ADDENDUM NO. 4

November 30, 2023

PROJECT: Port Perry Cannabis Facility, 8 Easy Street, Port Perry, ON

Attached: Water Service Sketch

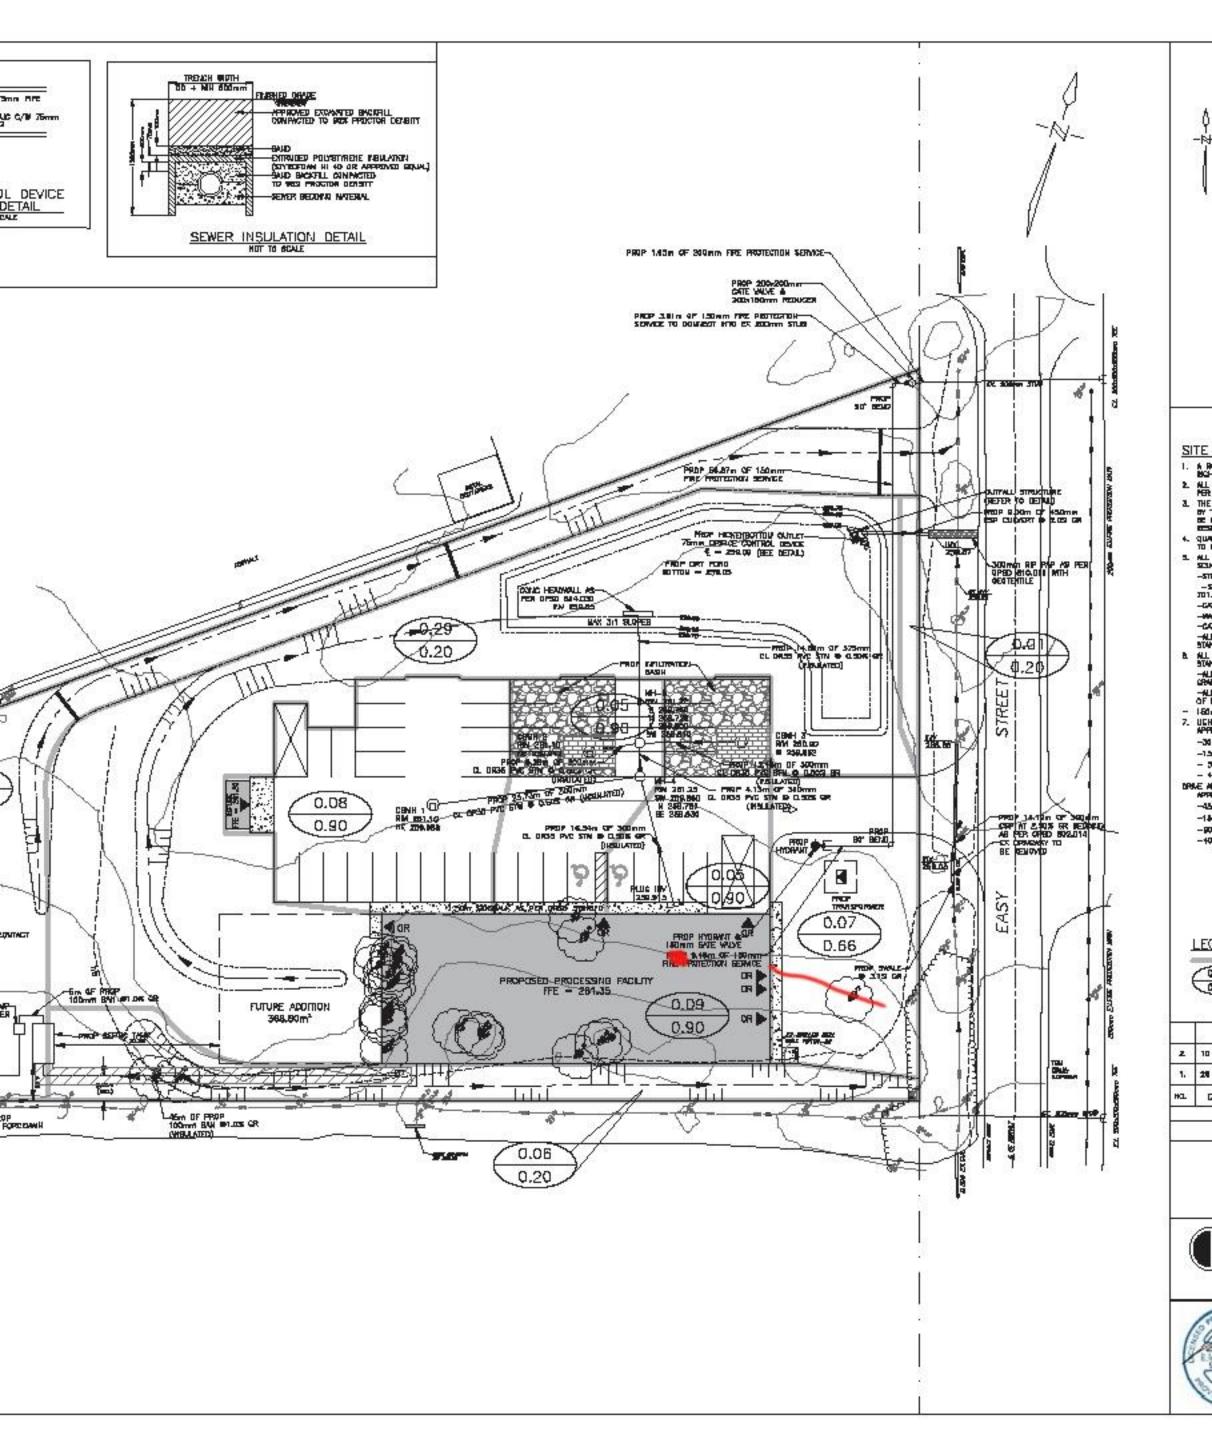
1. On SS-1 there is no mention of a water service to building or a water well if that is how it is to be supplied?

- A. Water will be from a well on the property as per the updated report from Cambium. See attached Cambium report and Water Service Sketch.
- I have gone through the architect's feedback (Addendum 3), but I still need some more information about the lift. The drawings show a lift plan that could be either a material lift for transporting materials and a rider, or a LULA elevator that is more suitable for passengers. Please clarify which type of lift they want? It could be either a material lift or a LULA elevator. Also, I would like to understand why the drawings include a scissors lift if it is not needed.
- A. Elevator, is to be a standard LULA elevator suitable for passengers as follows: size of elevator should be around 7' deep by 5' wide. Door should be 4' minimum. Travel between two stories.
